## **REBUTTAL FROM JONATHAN MUNDY IN RESPECT OF HIGHWAYS AND TRANSPORTATION**

Outline Planning Permission For The Demolition Of Existing Buildings And Development Of Up To 75 Dwellings, Open Space, Vehicular Access Point From Newgate Lane And Associated And Ancillary Infrastructure, With All Matters Except Access To Be Reserved. Land At Newgate Lane (North) Fareham.

APPEAL REFERENCE APP/A1720/W/20/3252180

Outline Planning Permission For The Demolition Of Existing Buildings And Development Of Up To 115 Dwellings, Open Space, Vehicular Access Point From Newgate Lane And Associated And Ancillary Infrastructure, With All Matters Except Access To Be Reserved. Land At Newgate Lane (South) Fareham.

Figure 1 – Linsig extract for indicative arrow model

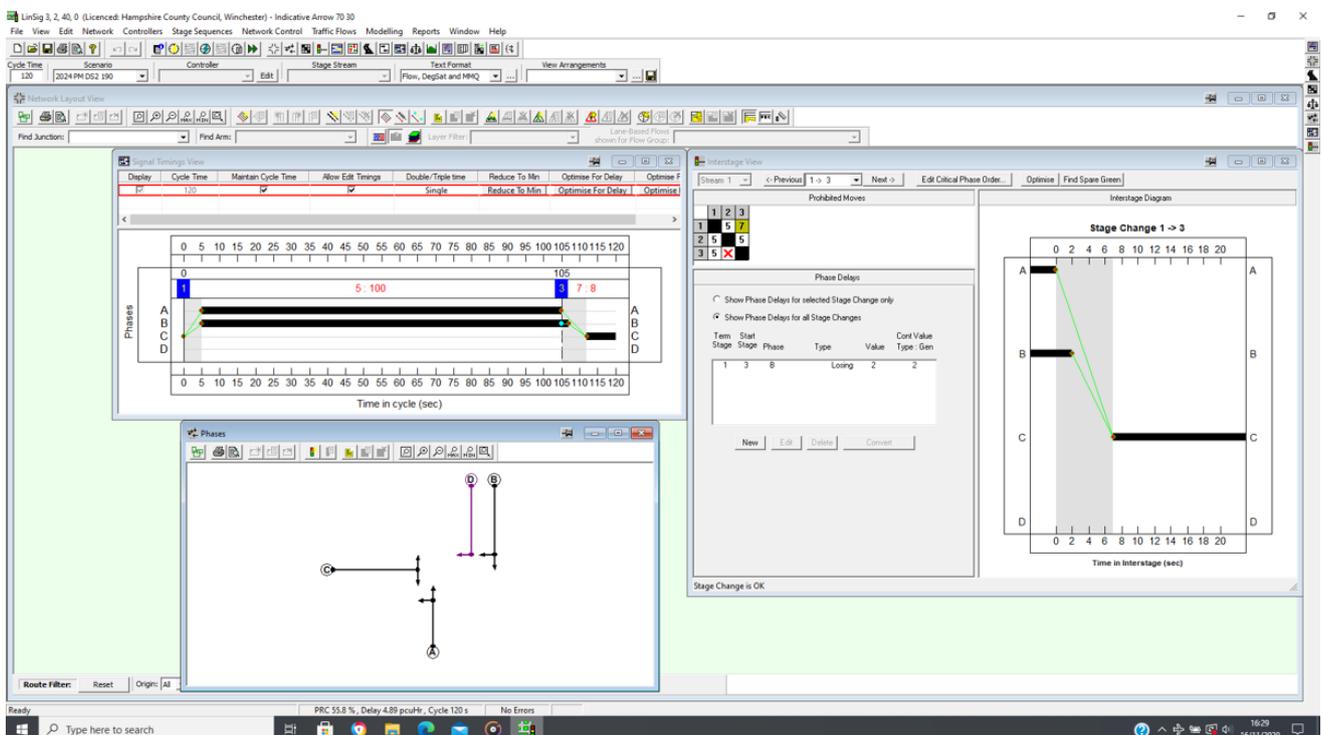
6.2 From the traffic signal Linsig model produced for the indicative option for each of the differing traffic distributions (FL&BH 3.2 Appendix F pages 87, 133, 179, 225 and 271) the 7 second duration stated above is incorrect. The duration is 5 seconds.

6.3 The model has intergreen times which are 7 seconds between phase A (Newgate Lane East northbound) and phase C (Old Newgate Lane) and 5 seconds between phase B (Newgate Lane East southbound) and phase C (Old Newgate Lane). The interstage period is 7 seconds (determined by longest phase intergreen). However the model includes a 2 second phase delay at the end of phase B (Newgate Lane East southbound) on a change from stage 1 (Newgate Lane East) to stage 3 (Old Newgate Lane). Figure 1 below shows these parameters.

6.4 The phase delay extends the appearance of the phase B green signal by a further 2 seconds beyond that of the phase A green signal. Drivers waiting in the centre of the junction to turn right in the intergreen period would seek confirmation from the secondary signal positioned in front of them. When this turns to red they would be assured that on-coming traffic would also be stopped and would start to turn when this changes to red. Effectively this provides 5 seconds in which to turn and not 7 seconds as stated.

6.5 Ms Hoskins evidence (5.26) also states that 3 vehicles could clear during the interstage period before the side road receives a green signal. The corrected 5 second intergreen period would comprise of 3 seconds leaving amber signal and 2 seconds starting red and amber signals. These are mandatory signal timings used throughout the country set in accordance with Department for Transport standards. Based on the correct 5 second intergreen period this would result in the signals being at red to all traffic for 0 seconds when changing from stage 1 (Newgate Lane East) to stage 3 (Old Newgate Lane). It is concluded that fewer than the 3 vehicles stated by Ms Hoskins could turn during this period.
